**Montgomery Bicycle Advocates**  
7121 Thomas Branch Dr.  
Bethesda, Md. 20817

**Re: Please do not reject ICC Trail "Option 3" in Rock Creek area**

Figure 4 Needwood Road Options

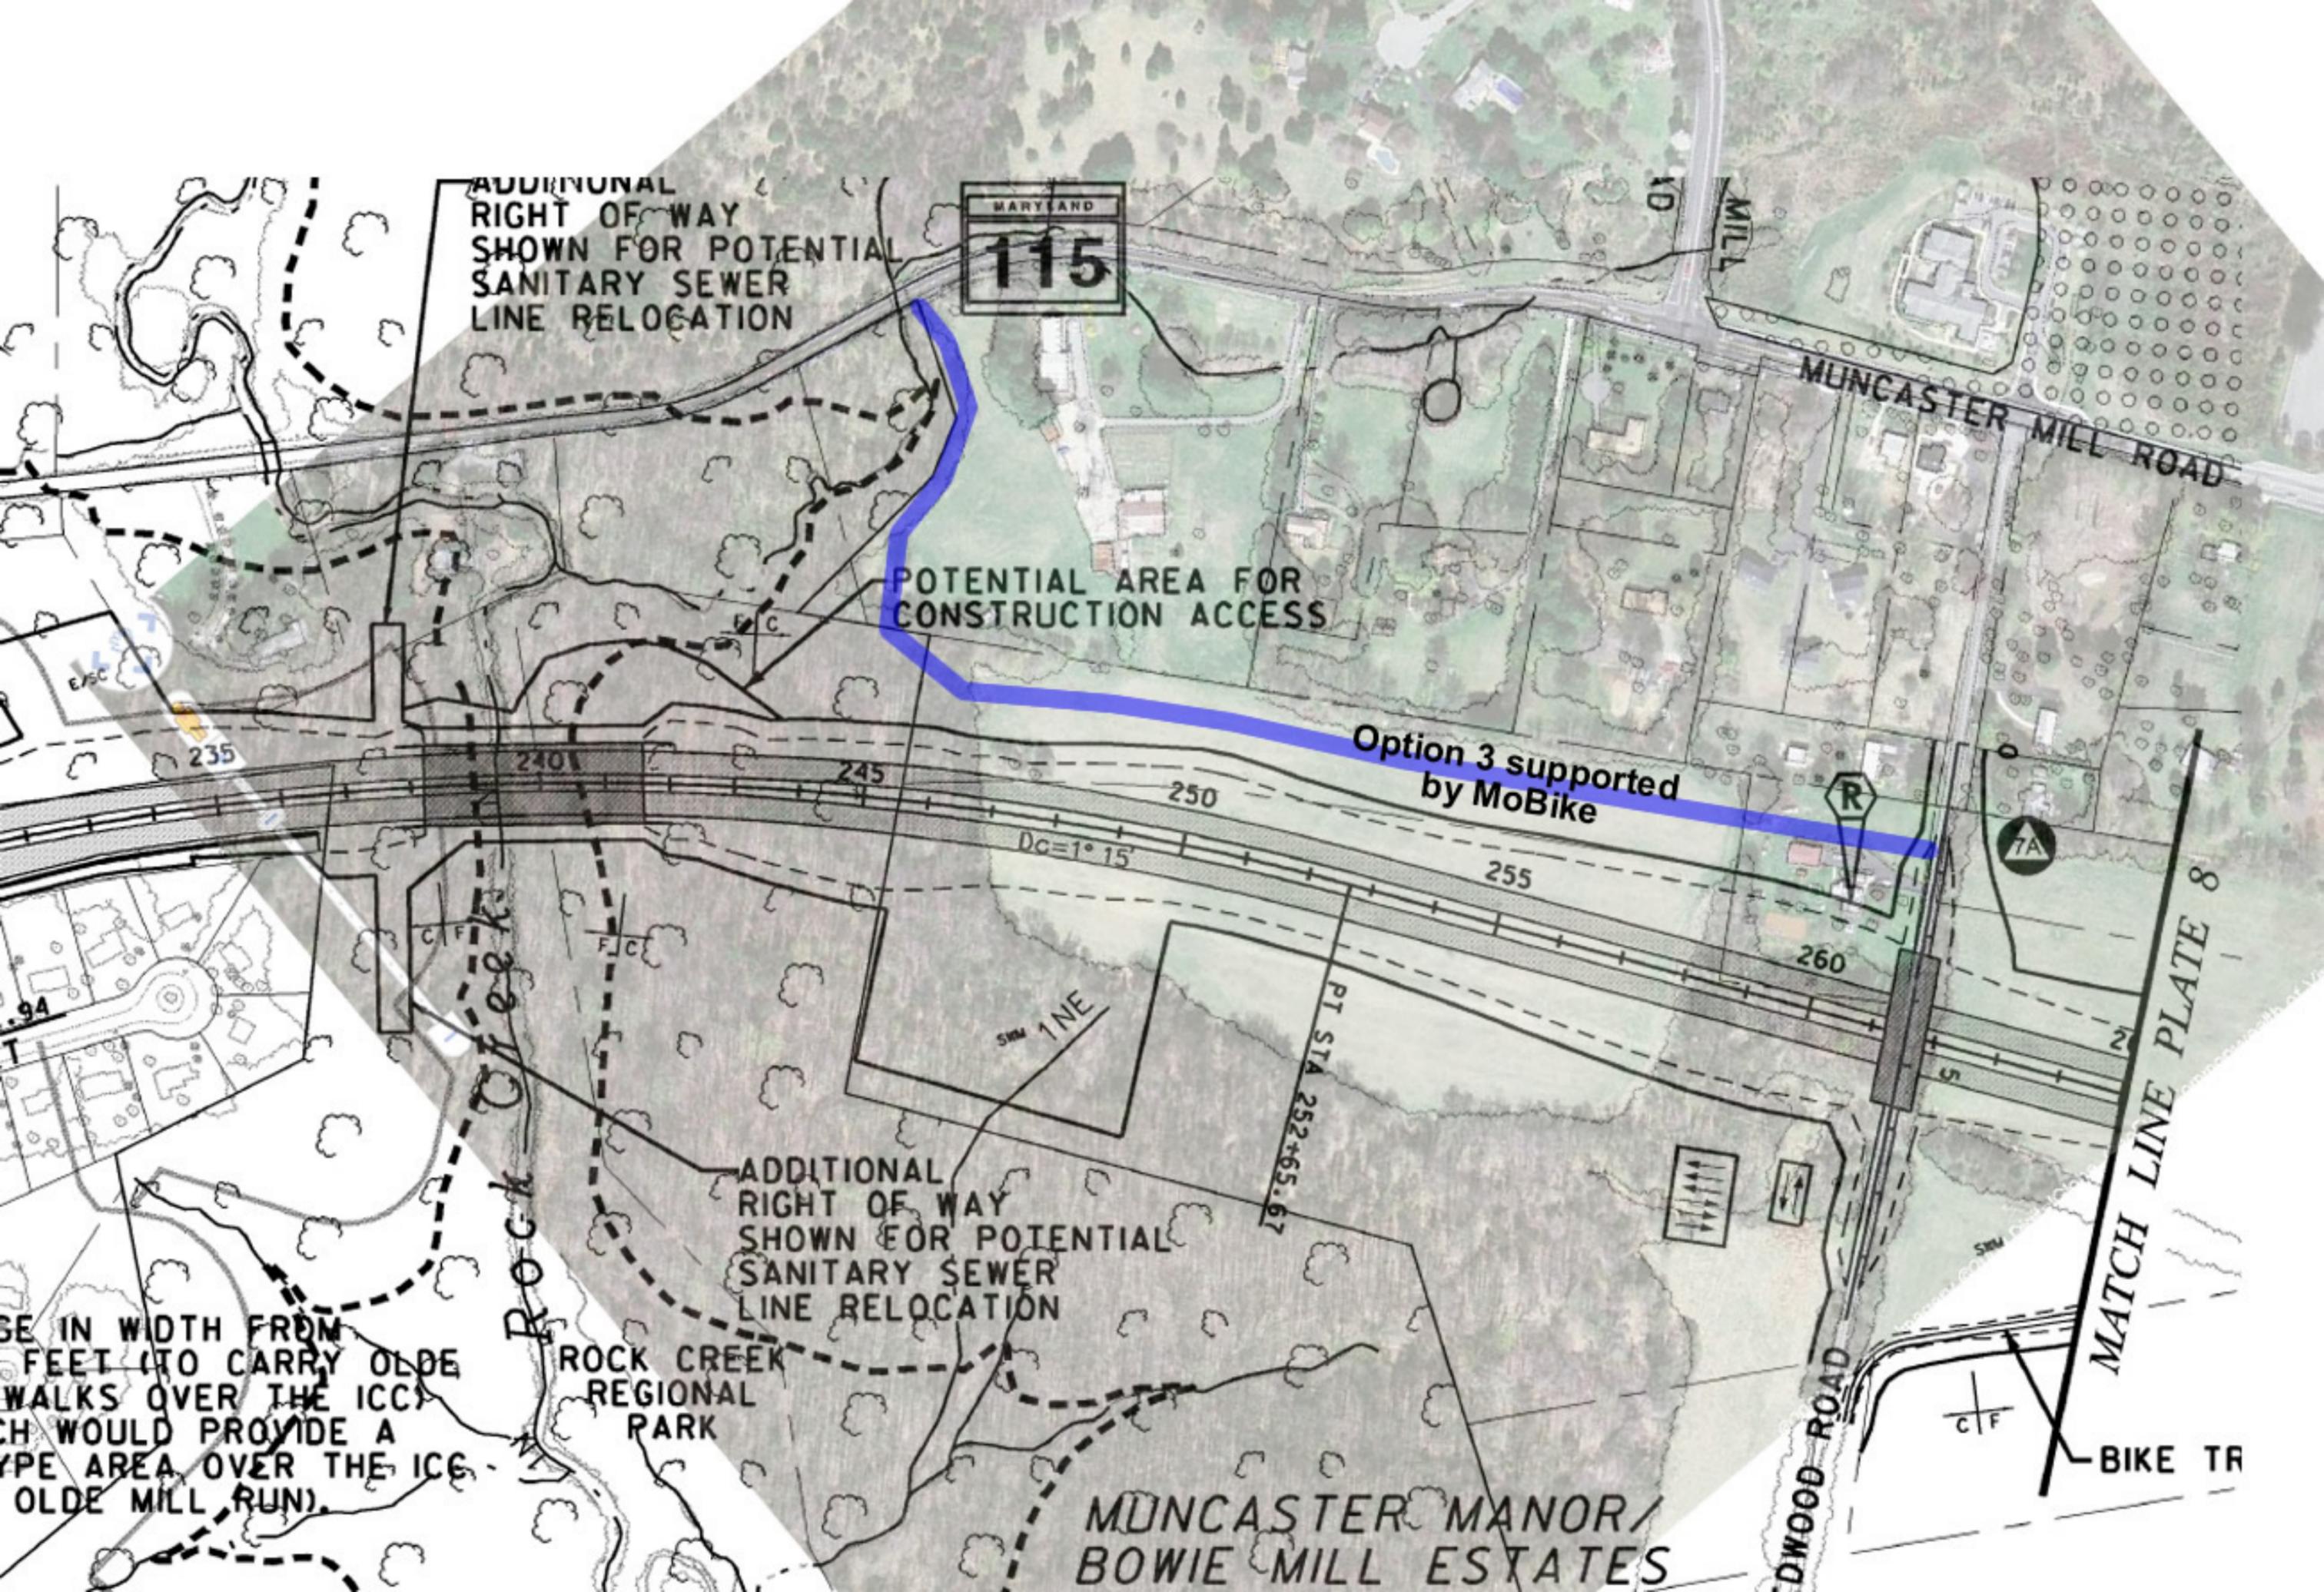
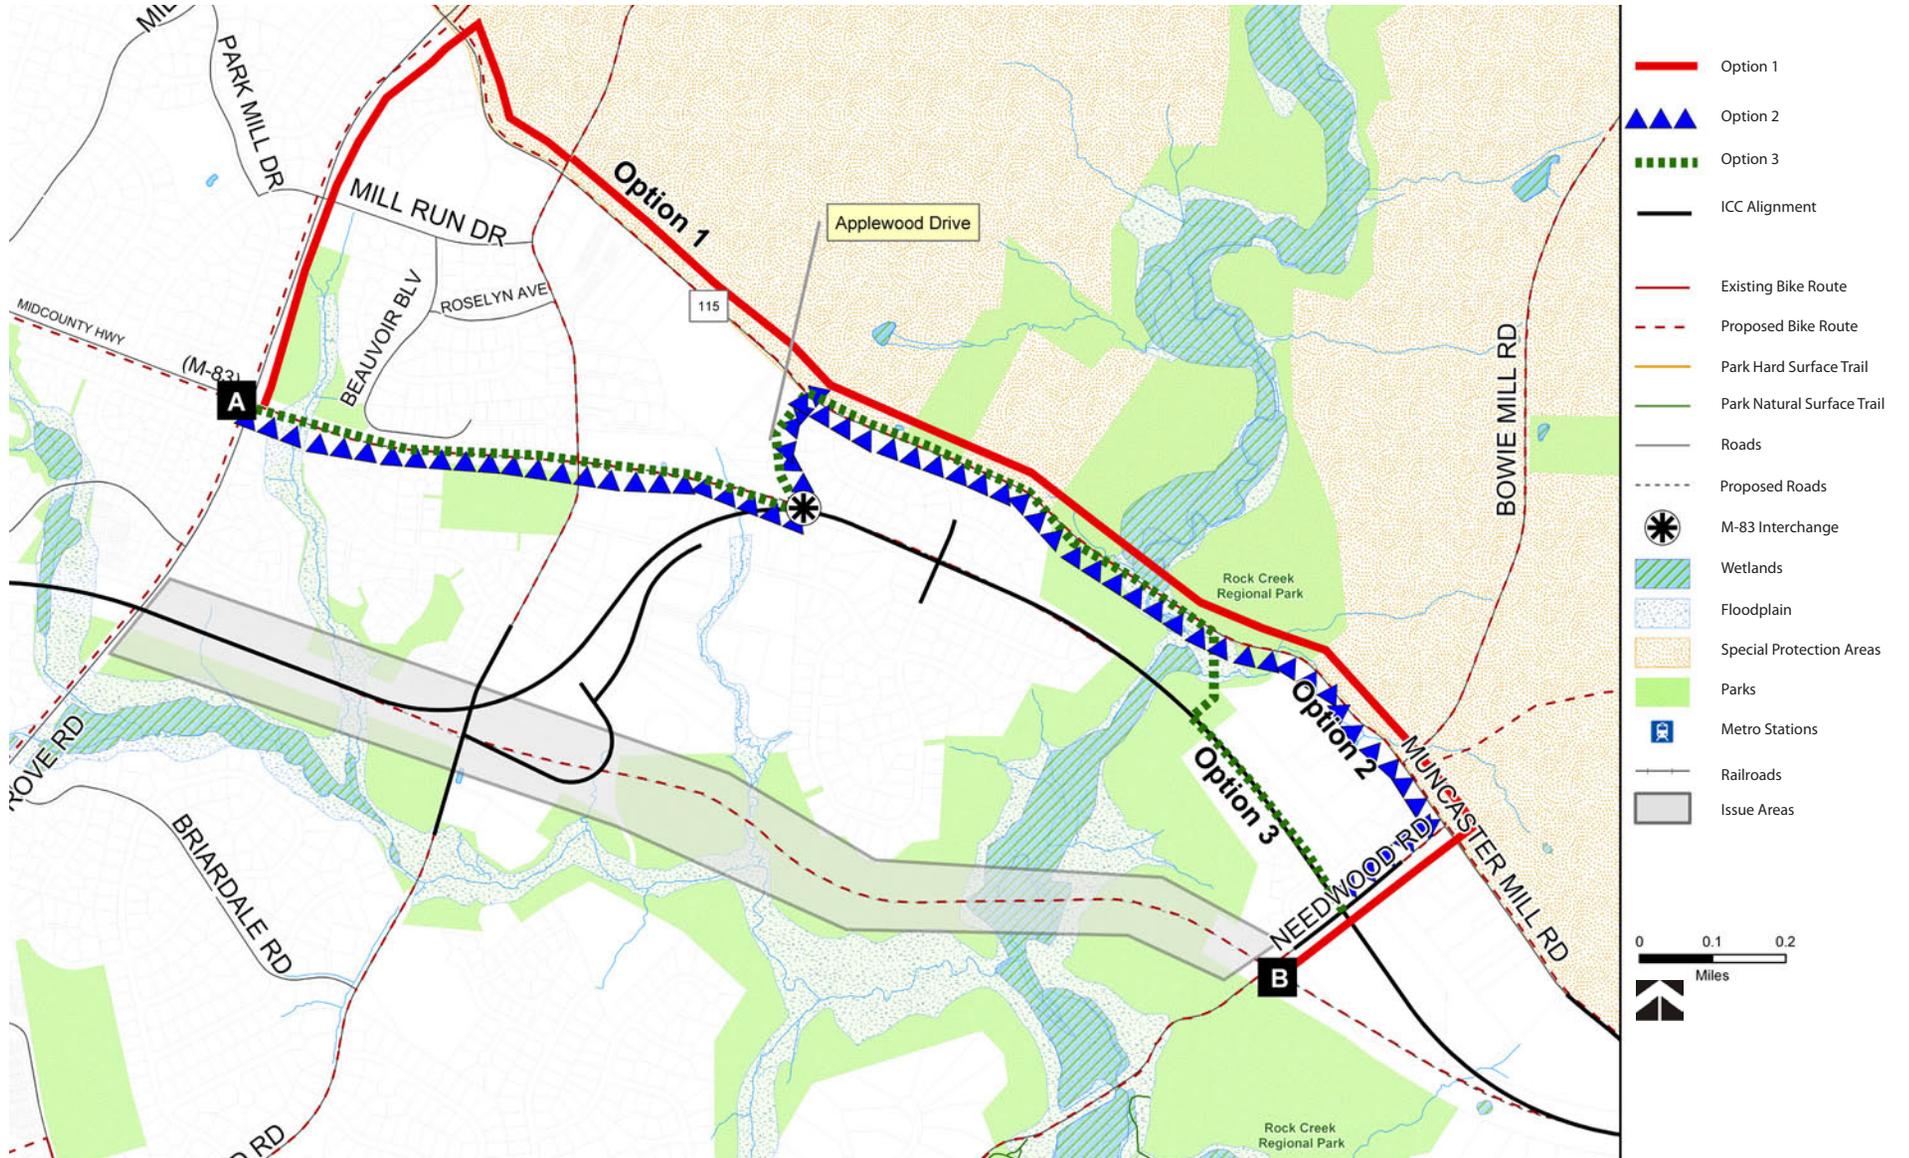
So pardon our persistence if we are still concerned about the section of trail along Muncaster Mill Road west of Needwood Road. Trail supporters have compromised to accept a general alignment along Muncaster Mill Road, but we can imagine no reason for M-NCPPC's rejection of the highly superior option in that corridor, called "Option 3" in the Master Plan Amendment (as depicted in the attached M-NCPPC diagram). The Council appears to be heading towards putting only Option 2 in the master plan. M-NCPPC's rationale for rejecting Option 3 is that it "connects through the park (and through wetland or along steep slopes)".

This is simply wrong. Option 3 doesn't go through these sensitive areas unless one tries very hard to pick the worst possible alignment. **Option 3 stays out of forest and flood plain (let alone wetlands) and is set almost entirely in a vacant strip of land sandwiched between the highway and backyards, maybe 200' wide.** Literally it's a field left vacant for construction of the ICC. The last leg of Option 3 turns north before it would otherwise have to enter the park, thus sparing parkland to be graced only by the gentle touch of the six-lane ICC highway. **This final 500' leg avoids forest and flood plain and could be built to skirt the park,** along the boundary between the park and the large institutional lawn next to the park – even on the private side if arrangements could be made.

**Option 3 is strongly preferred because it would avoid a number of driveway crossings and a signalized intersection.** Driveway and street crossings have been cited by trail supporters as the number one problem with the state's many ICC trail detours.

So please do not reject Option 3 until you have had the chance to look closely into its environmental impacts. One solution is to phrase the master plan amendment in a way that does not explicitly choose between Option 2 and Option 3 in this area, but makes it possible to implement either or both options after due analysis.

Option 3 supported  
by MoBike
